MODEL
**2017MY
Sorento (UMa)**

NUMBER
PS582 (Rev 1, 10/17/2018)

**BODY CONTROL MODULE (BCM)
PART NUMBER CHANGE**

Body Control Module (BCM)

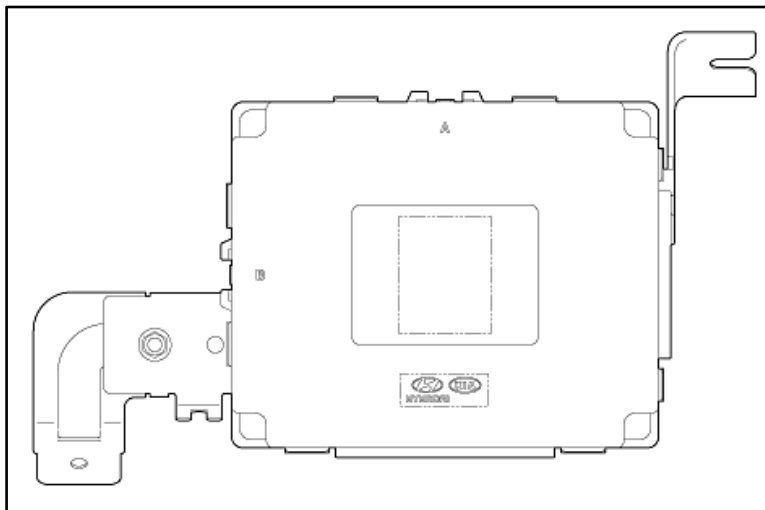
This Pitstop provides information regarding a change made to the software logic of the service part replacement Body Control Module (BCM) for the 2017MY Sorento (UMa). If the BCM is replaced with a normal service part, the horn answerback feature may not be available for selection within the settings menu of the instrument cluster. If the customer prefers the vehicle retains this feature, install the appropriate part below.

Normal Service Part	Service Part w/ Answer Back Feature
95410 C6020	95410 C6020AS
95410 C6040	95410 C6040AS
